Re: Sterling Downtown, 800 Silver Ave SW
Request for Certificate of Occupancy
Transportation Development Final Inspection
Architect's Stamp dated 08-04-17 (K13-D013)
Certification dated 06-27-18

DRAINAGE AND TRANSPORTATION INFORMATION SHEET (REV 3/2018)

RE: Sterling | Downtown
800 Silver Avenue SW
Albuquerque, NM 87102
Zone: SU-3 / Downtown 2025 Sector Development Plan
Submittal: TCL for Final C.O.

C1 SITE PLAN

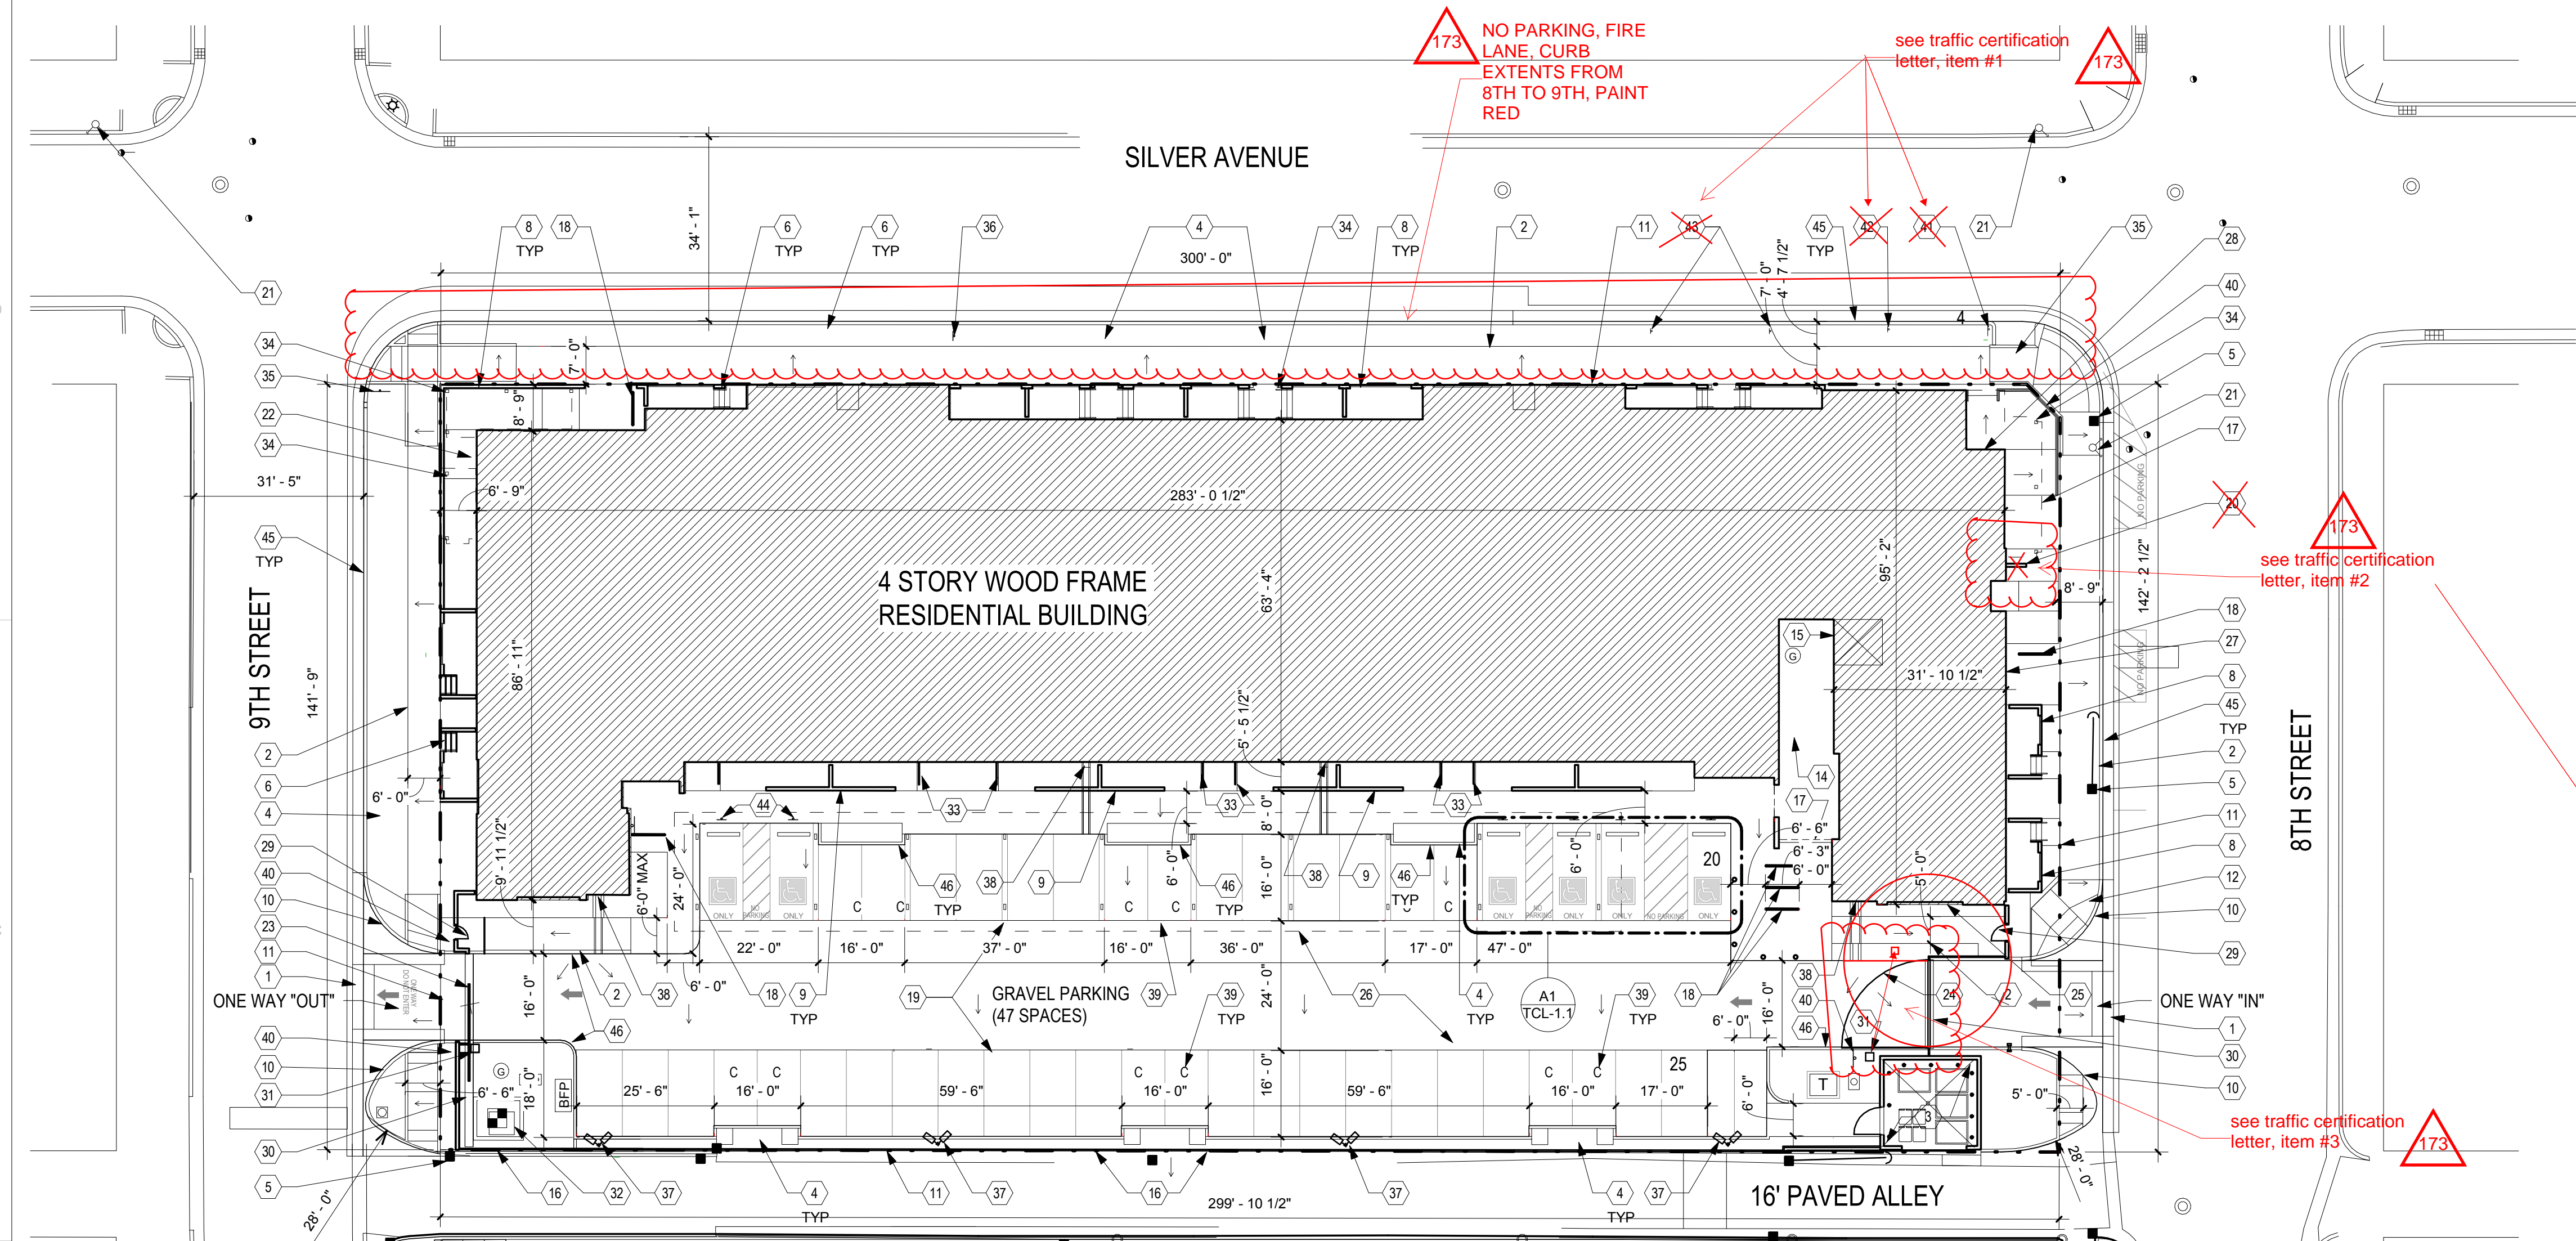
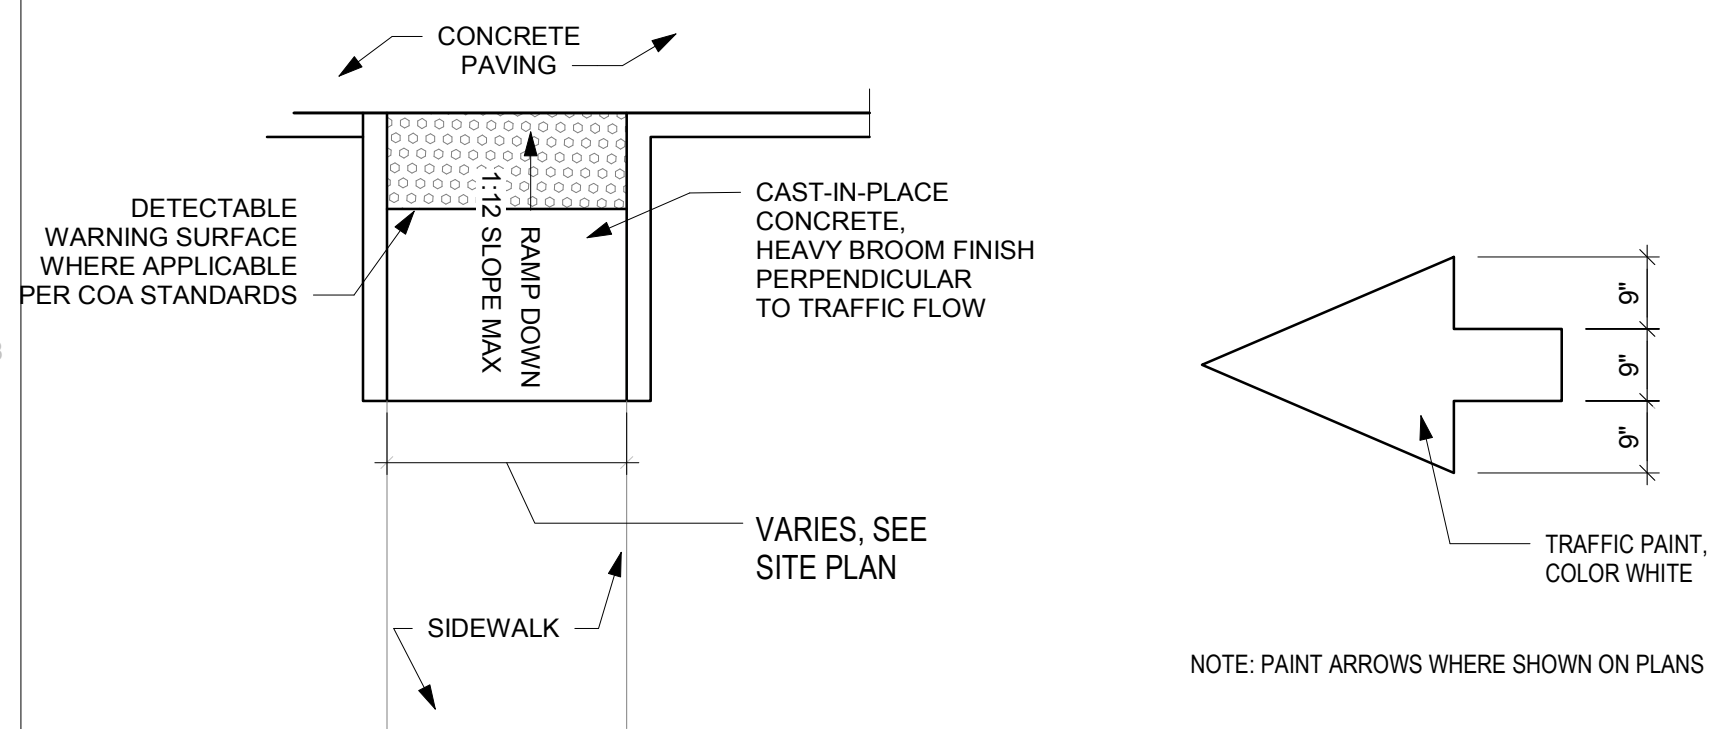
1. The property edge along Silver Avenue has been modified per the request of the fire marshal indicating that street parking on the south curb of Silver Avenue between 8th and 9th Street is not allowed. This curb has been striped for fire use only. Therefore, the three reserved street parking spaces as indicated on the TCL have been removed along with the signage indicated: LOADING ZONE, ZIP CAR PARKING, and FUTURE TENANT PARKING.

2. Due to construction costs, an item listed on the TCL as "optional" have been removed:
 - a. Keynote 20 – Optional Metal Blade Sign with Mural Type Image

3. Gate swing was reversed on site at the 8th street entry due to space constraints for gate controller during construction. The gate controller (keynote 31) indicated near the trash enclosure at the southeast corner of the site along the south edge of the drive has been relocated to the north edge of the drive per requirements of operability of the adjacent gate.
